# Access Compliance Report

## Public Rights-of-Way

### (Curb Ramps)

Intersection ID: 31701	Main Street: ATLAS_CEDAR_DR	Cross Street: CAROLINA_LAUREL_CT	Location: NW
ADA ID: 843AFA94EBBA	Ramp Type: PerpDiag	Initial Pass/Fail: Fail	Overall Compliance: No
		Severity Score: 10

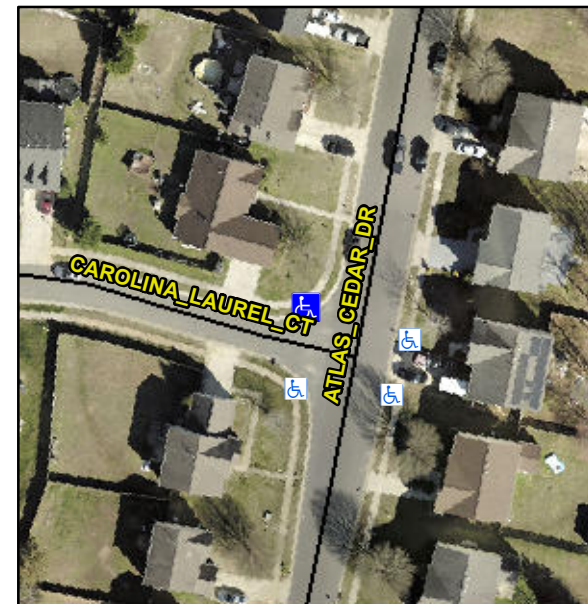
**Not Found, R304.5.1, R304.5.3**

Compliance	Description	Data	Compliance	Description	Data
N/A	Ramp Length (in)	48.0	Yes	Ramp Slope (%)	7.4
No	Ramp Width (in)	38.5	No	Ramp XSlope (%)	4.7
N/A	Flare Type LT	N/A	N/A	Flare Type RT	N/A
N/A	Flare Slope LT (%)	N/A	N/A	Flare Slope RT (%)	N/A
N/A	Flare Traversable LT?	N/A	N/A	Flare Traversable RT?	N/A
N/A	Landing Length (in)	N/A	N/A	DWS Provided?	N/A
N/A	Landing Width (in)	N/A	N/A	DWS Contrast?	N/A
N/A	Landing Slope (%)	N/A	N/A	DWS Length (in)	N/A
N/A	Landing X Slope (%)	N/A	N/A	DWS Full Width?	N/A
N/A	Landing Curb? (Y/N)	N/A	N/A	DWS Offset (in)	N/A
N/A	Shared Landing?	N/A			
N/A	Gutter Ponding?	N/A	N/A	Gutter Slope (%)	N/A
N/A	Gutter Lip Ht (in)	0.5	N/A	Gutter X Slope (%)	N/A
N/A	Painted X Walk1?	No	N/A	Painted X Walk2?	No
	X Walk 1 Direction	To S		X Walk 2 Direction	To E
N/A	X Walk 1 Width (in)	N/A	N/A	X Walk 2 Width (in)	N/A
	X Walk 1 Slope (%)	1.9		X Walk 2 Slope (%)	3.8
	X Walk 1 X Slope (%)	1.2		X Walk 2 X Slope (%)	3.0

**Remove & Replace Curb Ramp With Two New Directional Ramps or Equivalent.**
